**SAFETY EVALUATION REPORT
FOR RENEWAL OF
SOURCE MATERIAL LICENSE NO. SUA-1534**

**CROW BUTTE RESOURCES, INC.
CROW BUTTE URANIUM PROJECT
DAWES COUNTY, NEBRASKA**

FEBRUARY 1998

**U.S. Nuclear Regulatory Commission
Office of Nuclear Material Safety and Safeguards
Division of Waste Management**

Figure 2-1. Process flow sheet (CBR, 1995)

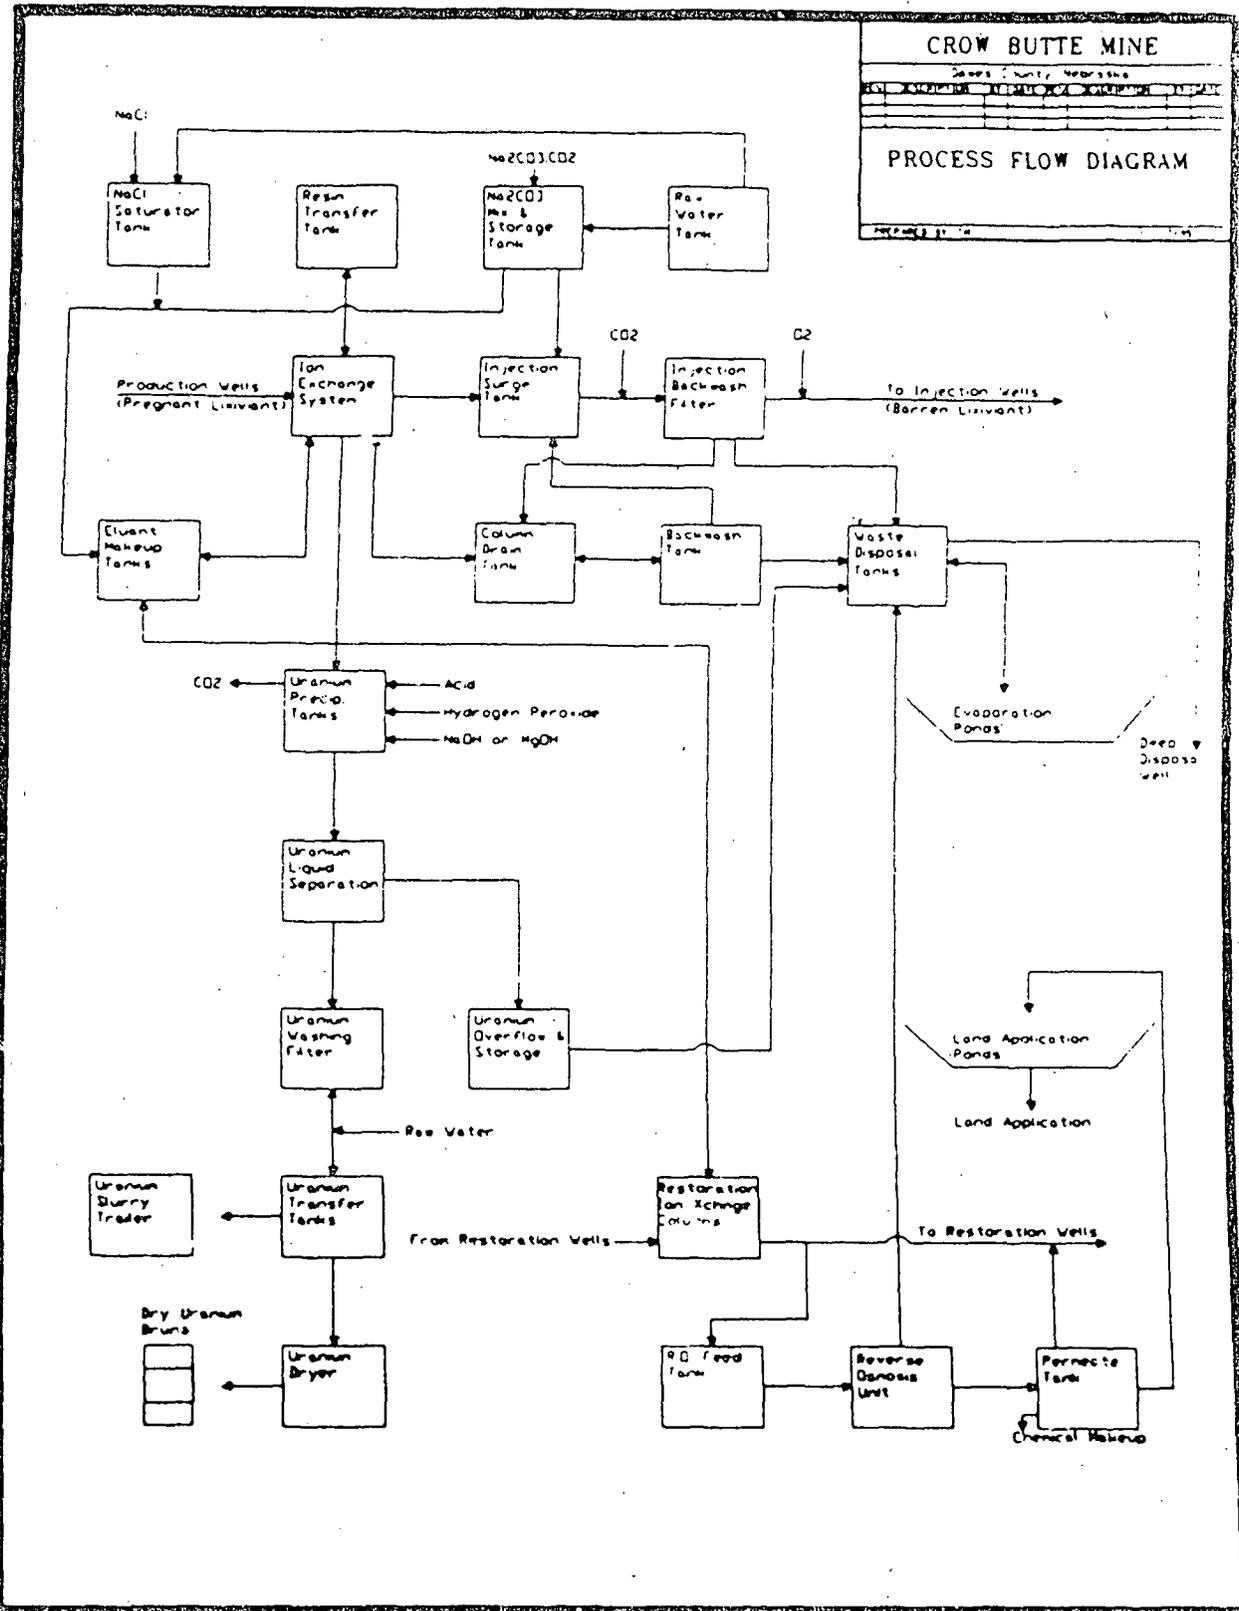
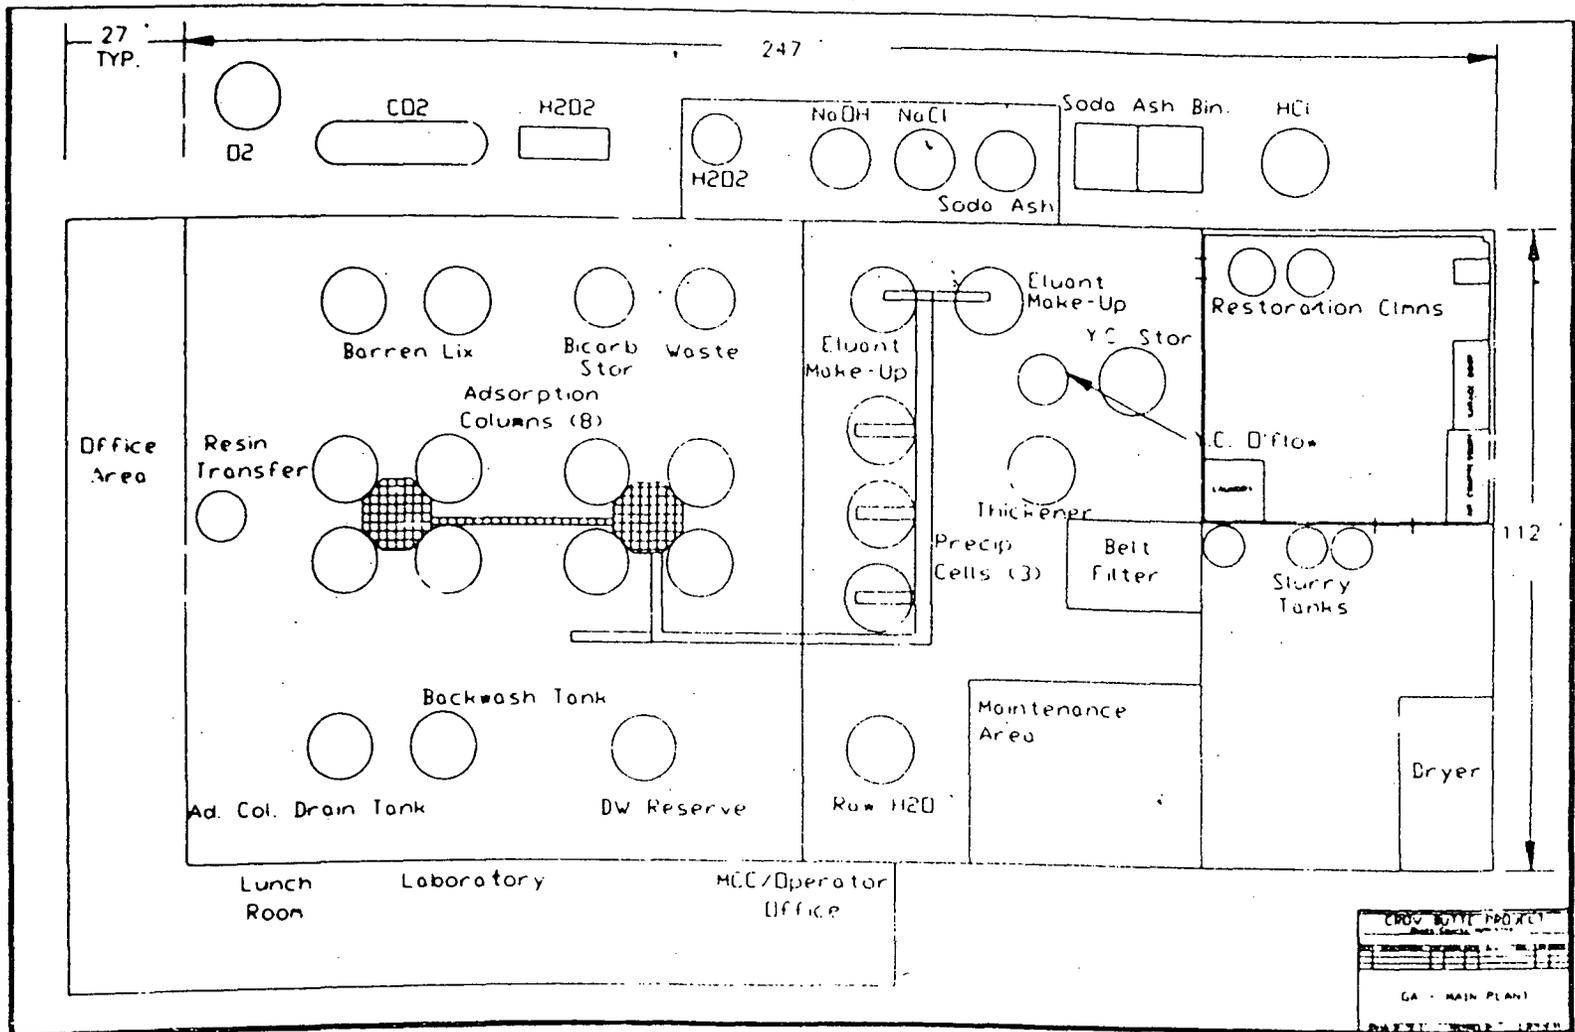
The general process circuit configuration is shown in Figure 2-1. The general layout of the processing plant is shown in Figure 2-2. The configuration of this process circuit has been reviewed by the NRC staff, and it represents a typical circuit for this type of operation.

CBR may make changes to the process circuit in accordance with the PBLC, as long as the changes do not degrade the essential safety commitments made in the LRA and do not impair CBR's ability to meet all applicable NRC regulations.

Figure 4-1. Proposed survey and sampling locations (CBR, 1997d)

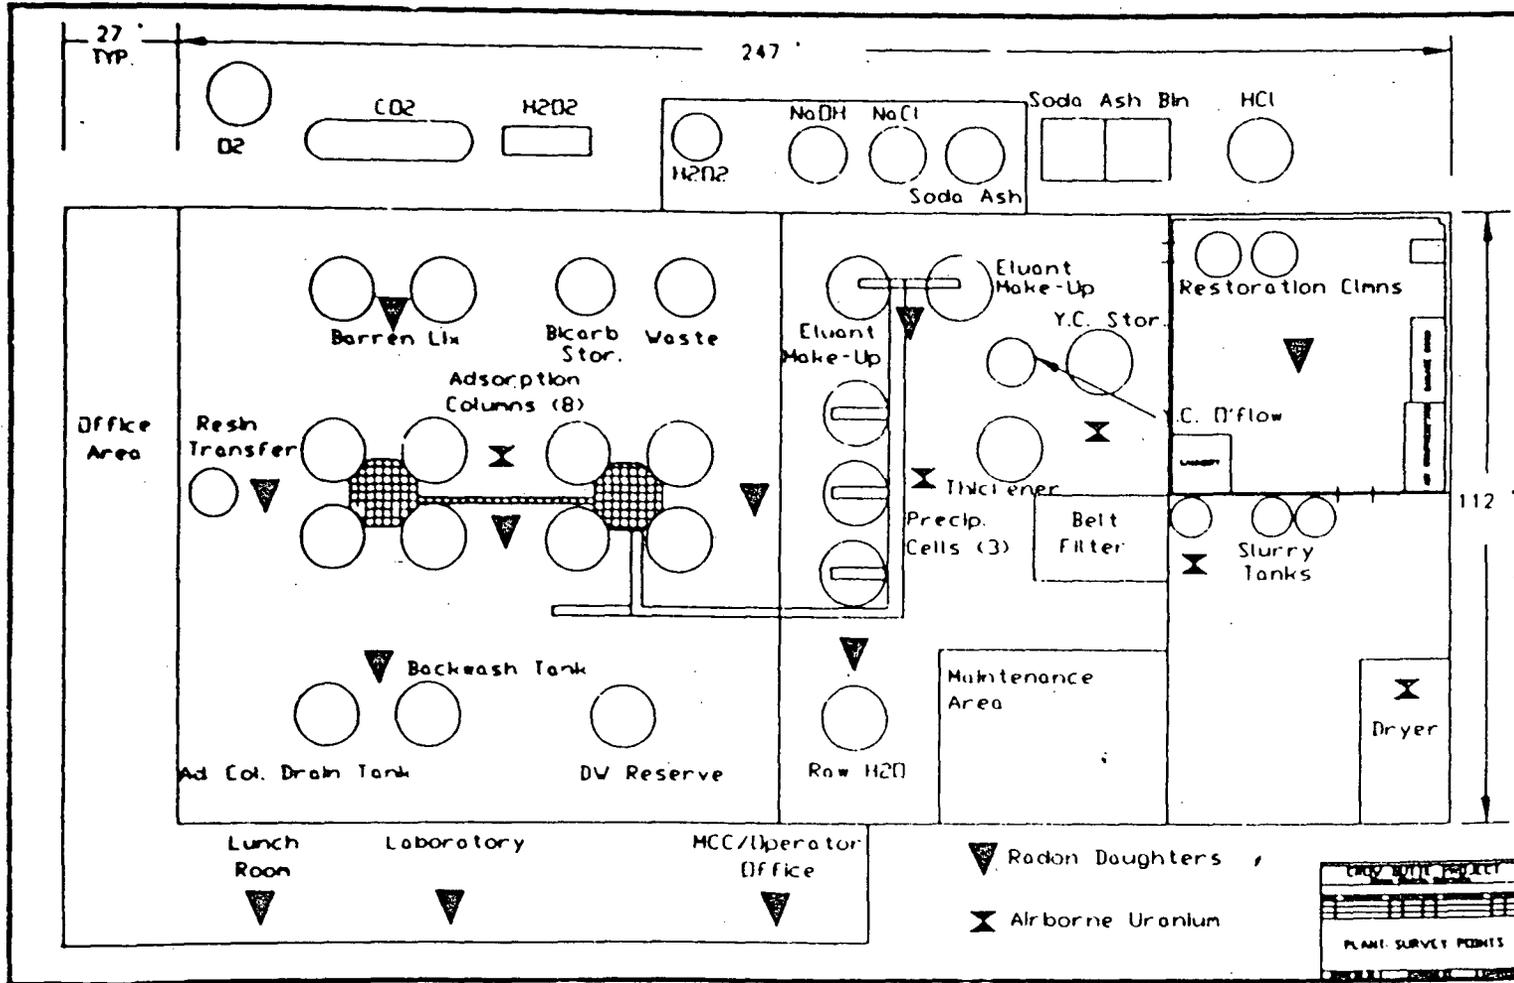
Area airborne sampling for uranium particulates is conducted, on a monthly basis, at the four locations shown in Figure 4-1. In addition, samples are taken in the dryer room during dryer operations and when RWPs are issued for this area. Average annual and maximum monthly gross alpha activity results from 1990 to 1996 were below 25 percent of the Maximum Permissible Concentration or the Derived Air Concentration (DAC) (after January 1, 1994) specified in 10 CFR Part 20.

CBR conducts radon daughter surveys on a monthly basis at 11 in-plant sampling locations (Figure 4-1) and at an additional location in the reverse osmosis building. During commercial operations, the action level of 0.08 WL has been exceeded on several occasions. CBR conducted appropriate investigations and corrective actions to address these situations. Average monthly and annual radon daughter activities during the period of commercial operations have been less than 25 percent of the maximum permissible exposure limit or the DAC (after January 1, 1994).

As discussed in Section 4.2, area airborne sampling for uranium particulates is conducted, on a monthly basis, at the four locations shown in Figure 4-1. In addition, samples are taken in the dryer room during dryer operations and when RWPs are issued for this area. CBR collects samples in accordance with an applicable SOP using a regulated air sampler, which is calibrated every six months. Measurements are made by performing gross alpha counting of a glass fiber filter. CBR also takes breathing zone samples using an MSA pump or equivalent, to assess individual exposures to airborne uranium during certain operations. The sample results are compared with the DAC for soluble natural uranium (classification D). CBR has instituted an action level of 25 percent of the DAC, such that if sample results exceed this value, an investigation is implemented.

CBR conducts radon daughter surveys on a monthly basis at the 11 in-plant sampling locations shown in Figure 4-1, and at an additional location in the reverse osmosis building. Samples are collected using a low-volume air pump and analyzed with an alpha scaler using the Modified Kusnetz method (ANSI-N 13.8-1973). The samplers are calibrated every six months. CBR has established an action level of 25 percent of the DAC, or 0.08 Working Levels, for the in-plant locations. Survey results in excess of the action level will result in an investigation of the cause and an increase of sampling frequency to weekly until radon daughter levels do not exceed the action level for four consecutive weeks.

9. In-plant radiological monitoring for airborne uranium and radon daughters shall be conducted at the locations shown in Figure 5.7-1 in the approved license application.
